ADDENDUM AD 02

Project:	Provincial Fire Life Safety – Lynn Lake, Gillam, and Thompson Sites	
Commission Number:	21569.44, 21569.49, 21569.50	SMS Project No.: 25-001-16
Date:	November 13, 2025	
Pages:	2 + 2 attachment/s

Project:	PFLS Gillam Hospital	Addendum Number:	01
Owner:	PMH	Project Number:	2025-0285
Issued by:	SMS	Date Issued:	November 7, 2025
Distribution:	SMS – Ethan McTavish (emctavish@smseng.com) SMS – Martyn Borovystkyy (mborovystkyy@smseng.com)

Project:	PFLS Lynn Lake, Gillam, and Thompson Sites	Addendum Number:	01
Owner:	PMH	Project Number:	2025-0433
Issued by:	SMS	Date Issued:	November 7, 2025
Distribution:	SMS – Ethan McTavish (emctavish@smseng.com) SMS – Martyn Borovystkyy (mborovystkyy@smseng.com)

- .2 Refer to drawing E1-000 – Drawing List, Symbol Legend, General Notes and Electrical Details (addendum #2)
 - .1 Refer to Detail 2 – Fire Pumphouse – Electrical Detail.

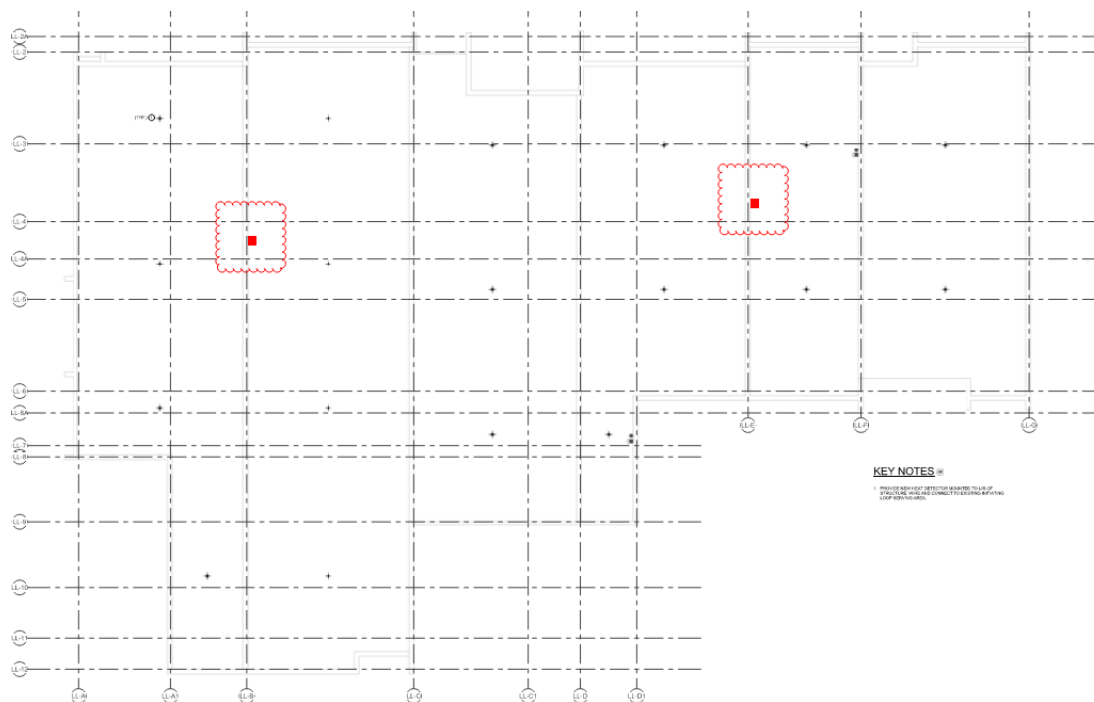
- .1 Provide new Class A initiating loop from new fire alarm control panel in hospital building to serve new devices in pumphouse building. Wire and connect new initiating devices (smoke detectors, pull station, monitor modules, etc.) to new class A loop.

- .2 Provide new Class B notification circuit c/w end of line device from new fire alarm control panel in hospital building to serve new devices in

pumphouse building. Wire and connect new notification devices (strobes and bells) to new class B circuit.

- .3 Refer to drawing E1-211 – Basement/Crawlspace Plan – Electrical – New Construction

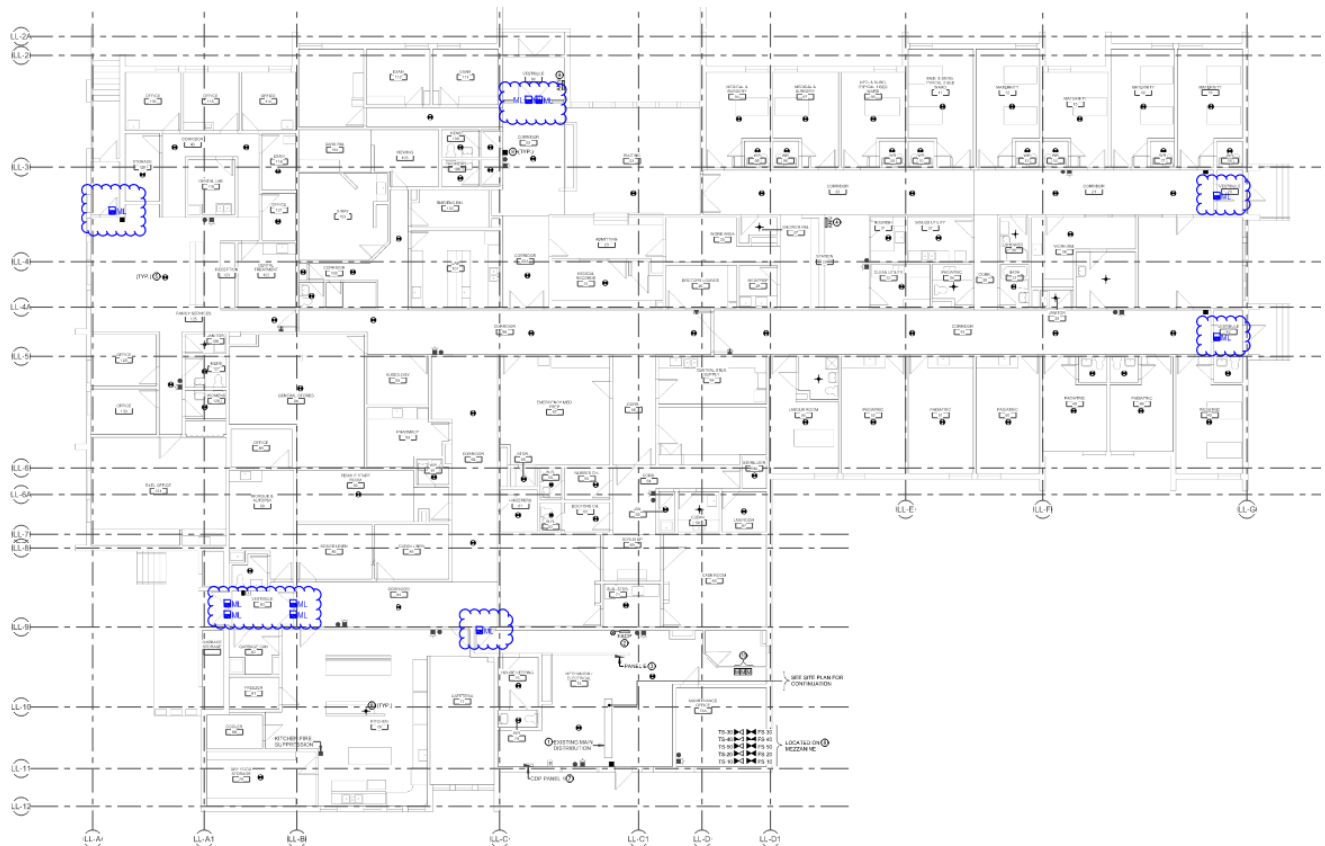
- .1 Provide new fire alarm pull stations at existing crawlspace access hatches in the following two (2) locations.
 - .1 Into main floor Corridor 100. Mount pull station to existing concrete beam adjacent to access hatch in crawlspace.
 - .2 Into main floor Soiled Utility room 32. Mount pull station to existing concrete beam adjacent to access hatch in crawlspace.

Wire and connect new pull stations to existing initiating loop serving area with capacity. Refer to below sketch for approximate locations identified on plans:

1 MAIN FLOOR - ELECTRICAL - NEW CONSTRUCTION
 11-201 11-201

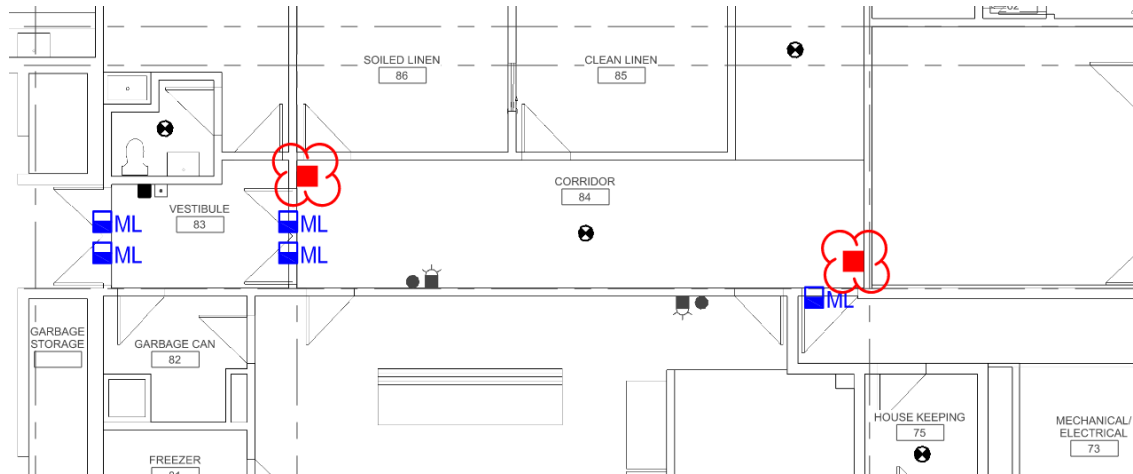
- .1 Provide new fire alarm relays at all existing magnetic locks and implement the following operations:
- .1 Magnetic locks throughout the facility shall release in accordance with fire alarm sequence of operation, refer to specifications for further information.
 - .2 Magnetic locks shall release from local pull station at each respective door (local door only).

See below sketch for existing magnetic lock locations:

- .2 Provide new fire alarm pull stations at two (2) locations in corridor 84 as illustrated below to release magnetic locks at those respective doorways.

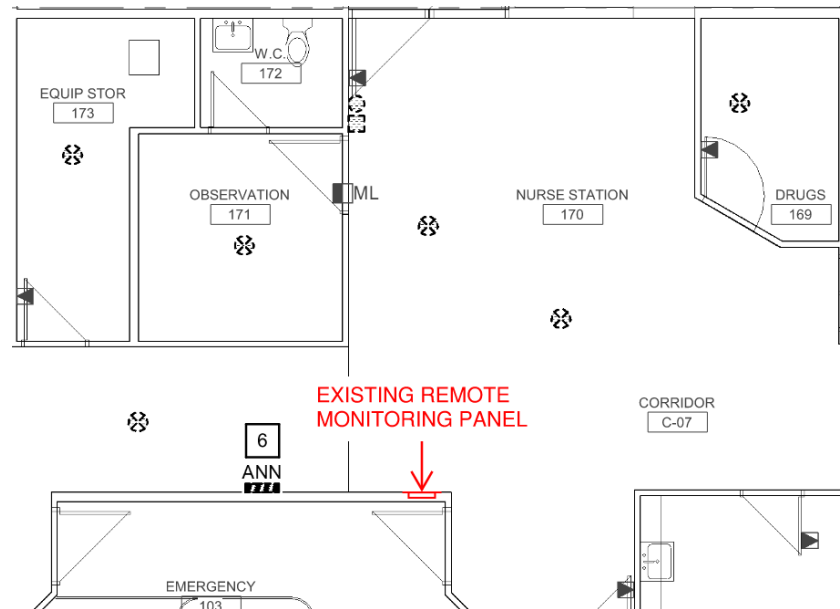
- .7 Refer to drawing E2-111 – Basement/Crawlspace Plan – Electrical – Demolition
- .1 Refer to existing metering to be demolished in corridor B-02. Remove existing current transformers (CTs) associated with utility meter from existing main distribution metering compartment in room B-04. Provide bus bar links where existing CTs have been removed to re-connect incoming and distribution sections. Arrange and pay for field re-certification of existing main distribution. Refer to photo below for existing main distribution equipment nameplate:

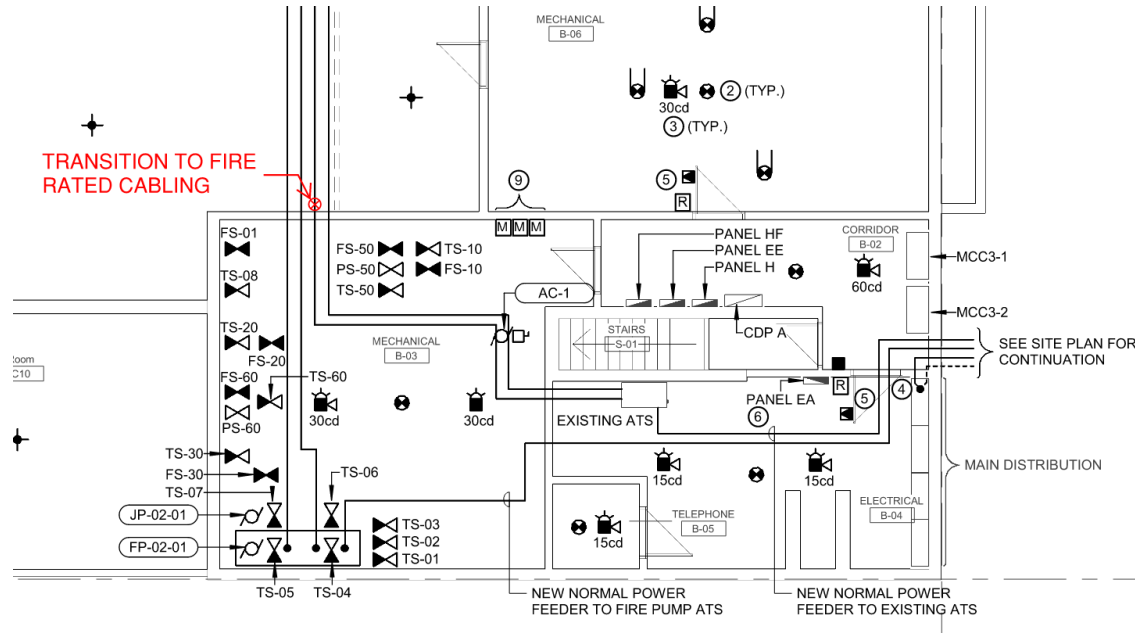
- .9 Refer to drawing E2-211 – Basement/Crawlspace Plan – Electrical – New Construction
- .1 Feeder from new CDP-EM1 in generator enclosure to existing ATS in basement electrical room B-04 shall be protected from fire for not less than two (2) hours with either one of the following methods:
- .1 Provide 2 hour rated bulkhead within room B-03.
OR
 - .2 Transition to fire rated cabling at wall between crawlspace and basement room B-03. Cable segment between crawlspace and existing ATS, through room B-03 shall be fire rated.

Fire rated cabling shall be selected to provide a minimum fire circuit integrity rating of not less than 2 hours.

Provide suitably sized pull box to accommodate transition on crawlspace wall. See below sketch for approximate location of transition:

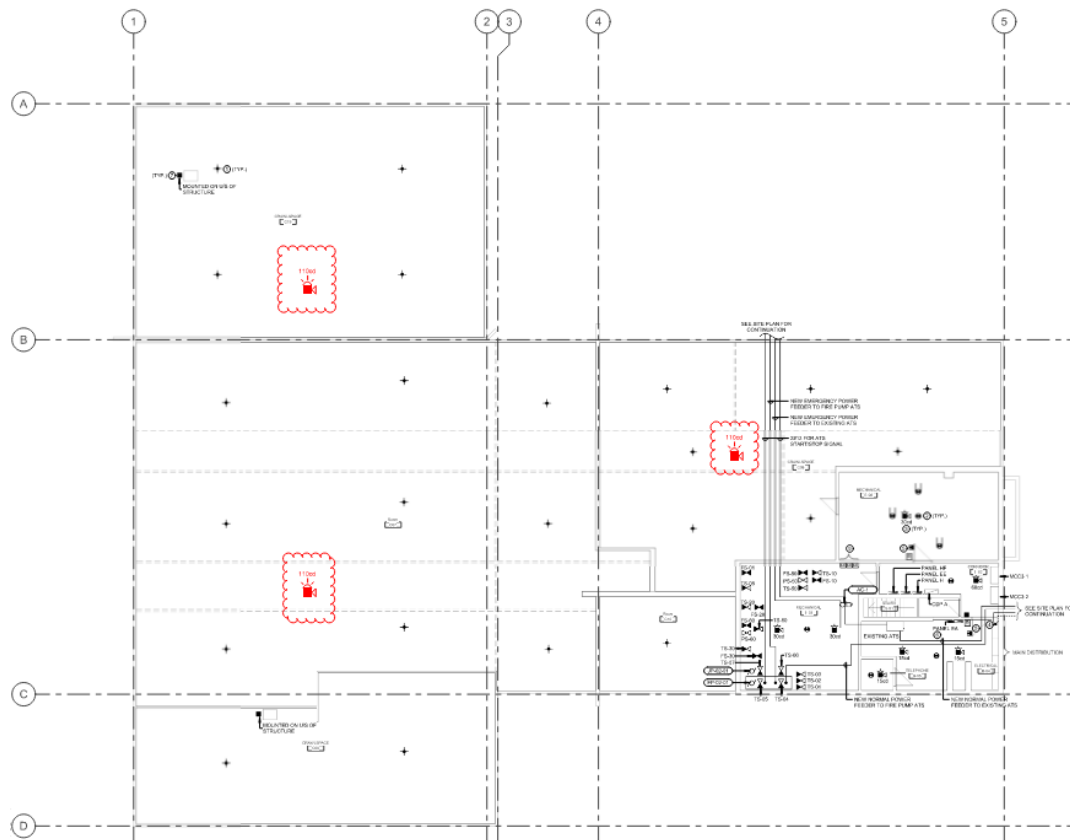
- .2 Provide five (5) new fire alarm monitor modules at new fire pump FP-02-01 to monitor the following points:
 - .1 M1: power/phase failure
 - .2 M2: phase reversal
 - .3 M3: trouble
 - .4 M4: motor run
 - .5 M5: alternate source

Coordinate installation with fire pump supplier. Wire and connect to new class A initiating loop serving area.
- .3 Provide standalone carbon monoxide detector and alarm within mechanical room B-03, refer to specification revisions for standalone CO detector requirements. CO detector shall be monitored by the fire alarm system.
 - .1 Provide new 120V emergency power circuit from existing panel EA located in basement electrical room B-04. Provide new 15A-1P breaker to match existing.
- .4 Provide three (3) new combination horn/strobe notification devices (110cd) in crawlspace. Refer to below sketch for locations. Devices shall be mounted on u/s of structure.

.2 Refer to drawing E2-221 – Main Floor Plan – Electrical – New Construction

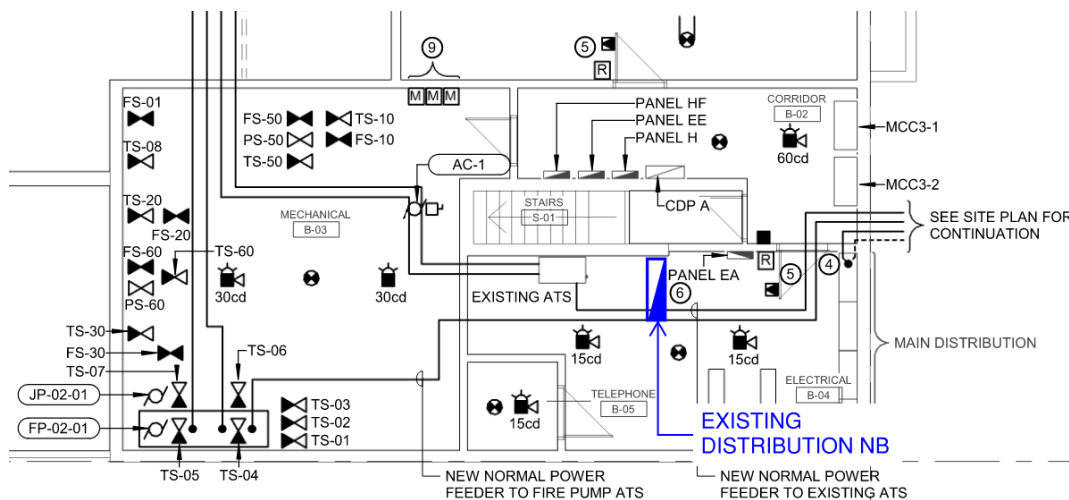
- .1 Provide new recessed remote monitoring panel for new generator, installed in the location of demolished existing near nurse station 170. Confirm wiring type and power requirements with generator manufacturer.
- .2 Provide new 120V circuit for new fire alarm control panel power supply in electrical room 123. Wire and connect to nearest existing life safety emergency power panel serving area with capacity. Coordinate breaker size with fire alarm manufacturer, new breaker shall match existing in all respects.
- .3 Provide carbon monoxide detectors of same manufacturer as the fire alarm system (not standalone), c/w sounder base in the following areas. CO detectors shall be monitored by the fire alarm system:
 - .1 Ward room 129
 - .2 Ward room 131
 - .3 Ward room 135
 - .4 Ward room 137
 - .5 Ward room 139
 - .6 Ward room 141
 - .7 Ward room 143

CO detectors are permitted to be a combination smoke/carbon monoxide detector with sounder base.

- .4 Provide new fire alarm relays at all existing magnetic locks to implement the operations identified in key note #9.
- .5 Refer to key note #8. Provide new additional wording as underlined below for key note to read as:
“Provide new mag-lock control panel to control all existing mag-locks. Standard of acceptance shall be model ACM8 (Altronix) or approved equal. Confirm operating voltage of existing mag-locks on site. Mag-locks to be controlled by existing key pad(s) at door locations.”

- .3 Refer to drawing E2-301 – Partial Single Line Diagram – Demolition and New Construction, Fire Alarm Riser Diagram and Motor Schedule
 - .1 Refer to Partial Single Line Diagram – New Construction, Detail 2.

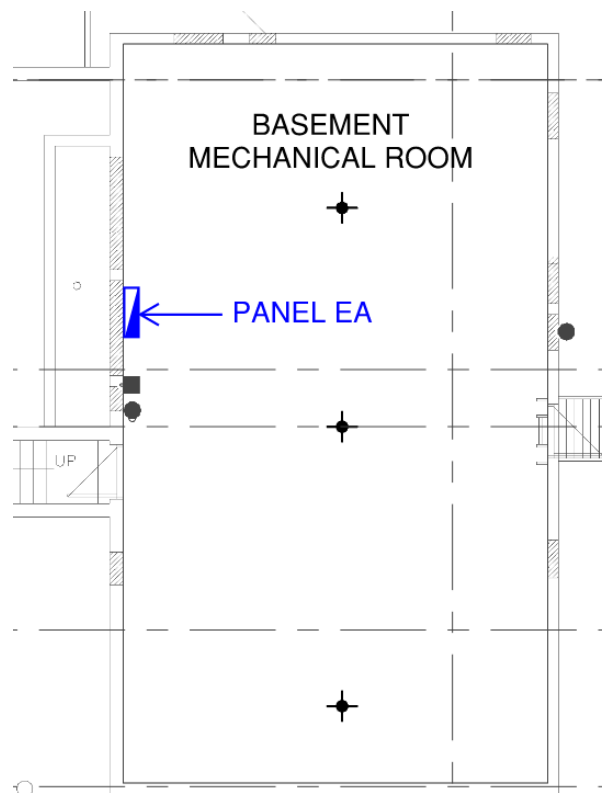
- .2 Refer to Fire Alarm Riser Diagram, Detail 3.
 - .1 Provide additional class A initiating loop from new fire alarm control panel to new outdoor E-House enclosure to connect smoke detector and pull station within E-House.

- .3 Call up new key note #13 at fire alarm control panel to read as: *"New fire alarm control panel shall include battery backup."*
 - .4 Call up new typical key note #14 at all NAC power supply panels to read as: *"Confirm power requirements with manufacturer prior to rough-in."*

- .5 Call up new typical key note #15 at all class B notification circuits to read as: *"Provide minimum one dedicated signalling circuit for each fire alarm zone to comply with CAN/ULC-S524:2019 circuit fault tolerance requirements."*

- .3 Provide new general notes to read as:
 - .1 *"D. Horn and strobe circuits shown are typical. Provide all horn and strobe circuits required based on circuit loading. Coordinate with fire alarm manufacturer."*

- .5 Refer to drawing E3-221 – Main Floor Plan – Electrical – New Construction
- .1 Revise room tag for room “RS 21” adjoining corridor 131 to instead read “RS 2”.

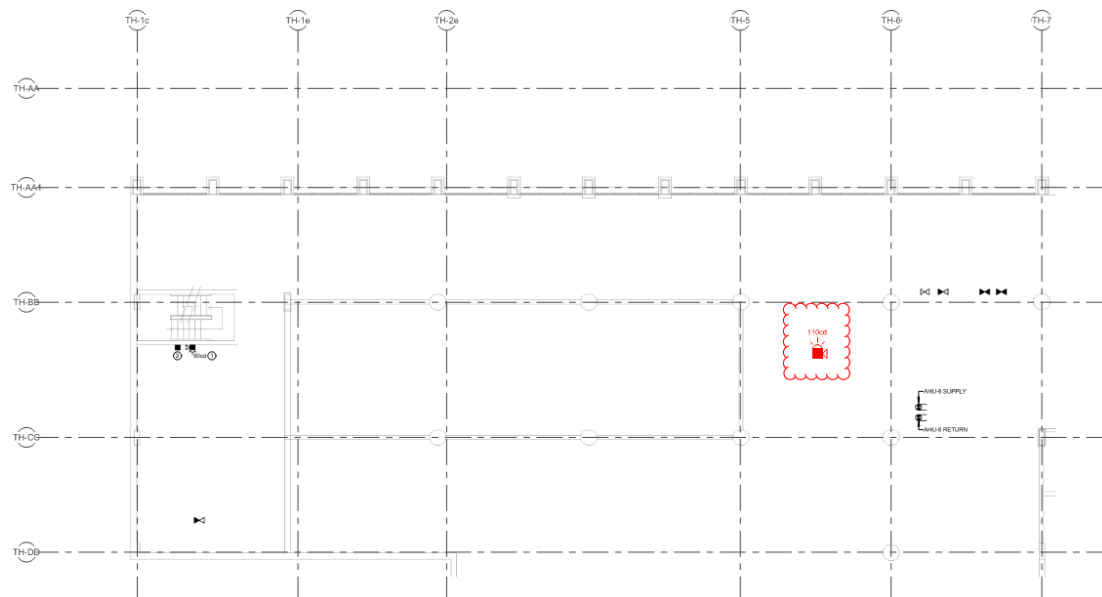
- .3 Provide standalone carbon monoxide detector and alarm within Laundry Room 106, refer to specification revisions for standalone CO detector requirements. CO detector shall be monitored by the fire alarm system.
-

- .1 Wire and connect to new 120V emergency power circuit from existing panel EA located in basement mechanical room, circuit may be shared with basement mechanical room CO detection.

GENERATOR PAD PLAN

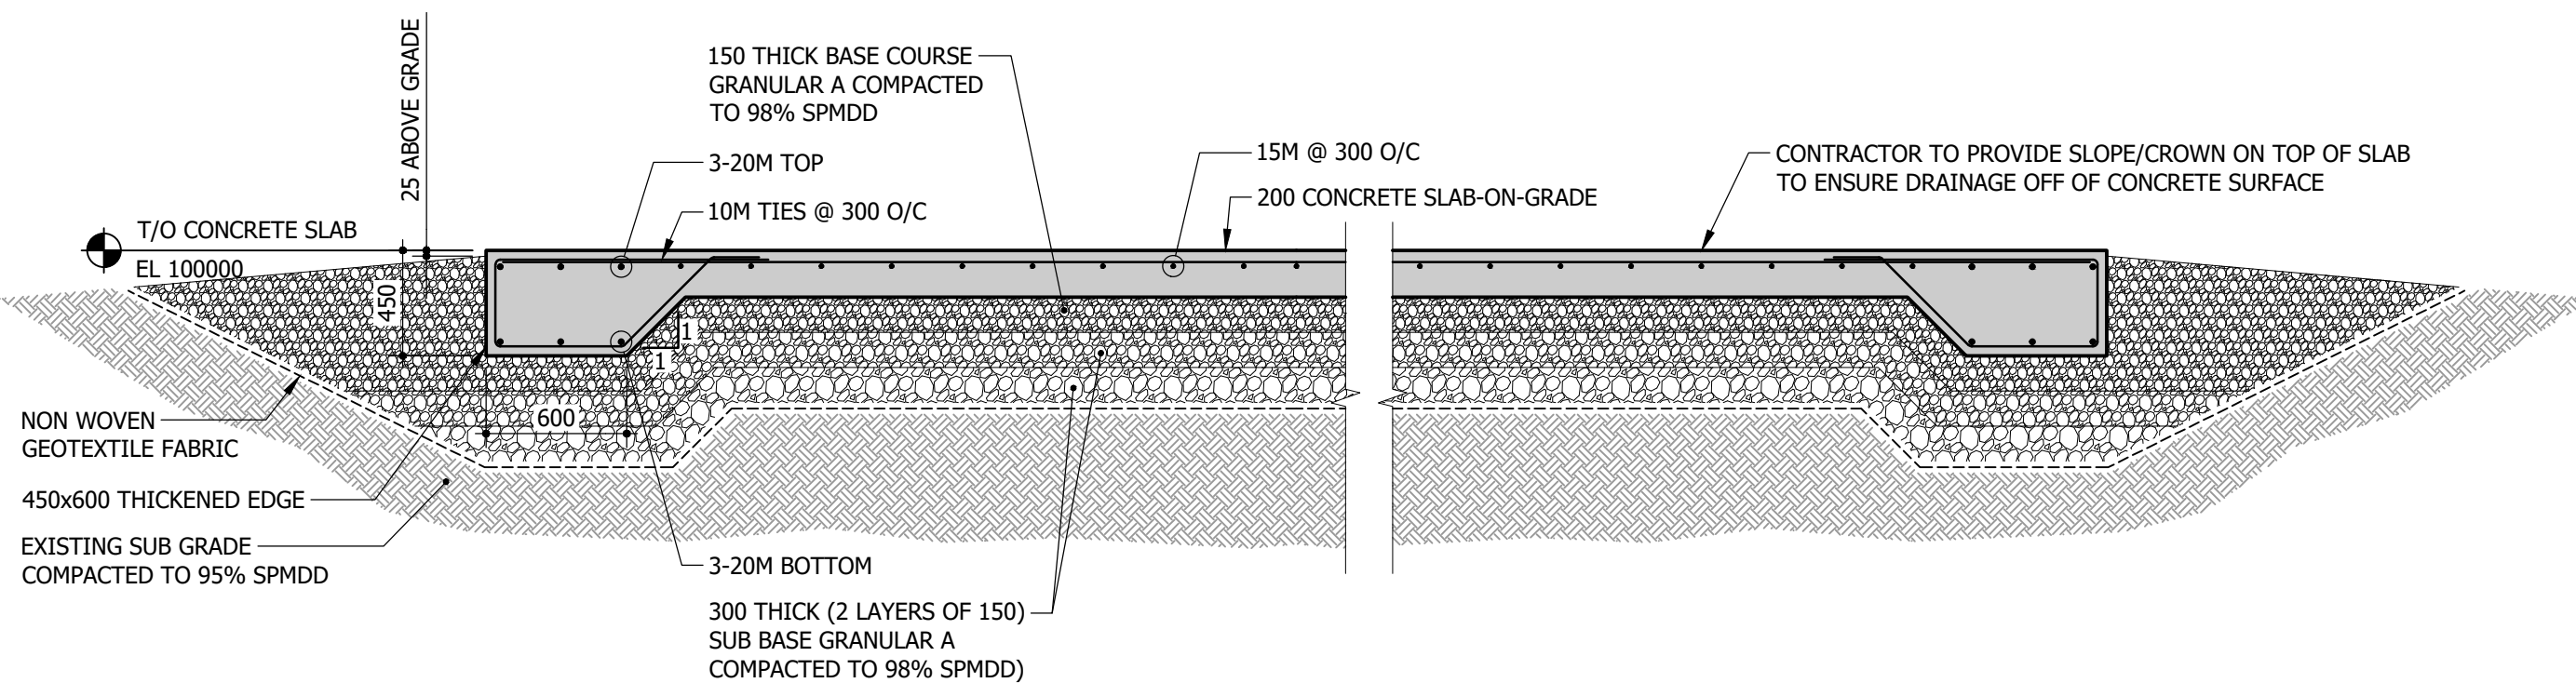
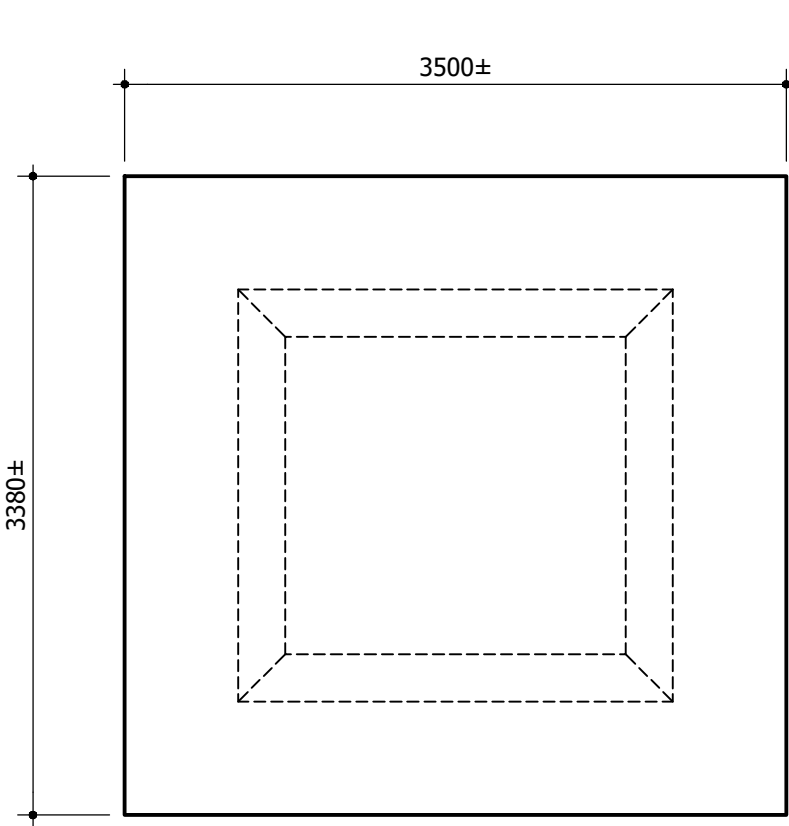
1. Refer to S2-001 (attached). Increased the Generator pad size and weight for the updated generator enclosure dimensions, size to be verified with shop drawings.
2. Refer to S2-001 (attached). Added 3,500mm x 3,380mm Electrical E-House concrete pad, refer to electrical for location. Size and weight to be verified with shop drawings. Existing propane tank concrete pad to be demolished.

- TOTAL LOAD $\approx 410 \text{ kN}$
- PAD DIMENSIONS TO BE CONFIRMED WITH CERTIFIED SHOP DRAWINGS. SEE SECTION 1/S2-001 FOR REINFORCING DETAILS.
- IF REQUIRED, HOUSEKEEPING PAD IS TO BE EXTENDED MINIMUM 150 BEYOND THE BASE OF THE GENERATOR/FUEL TANK ALL AROUND.
- SEE ELECTRICAL / ARCHITECTURAL FOR EXACT LOCATION.
- CONFIRM ELEVATION OF TOP OF SLAB ABOVE GRADE WITH ELECTRICAL. CONTRACTOR TO PROVIDE SLOPE / CROWN ON TOP OF SLAB TO ENSURE DRAINAGE OFF OF CONCRETE SURFACE.
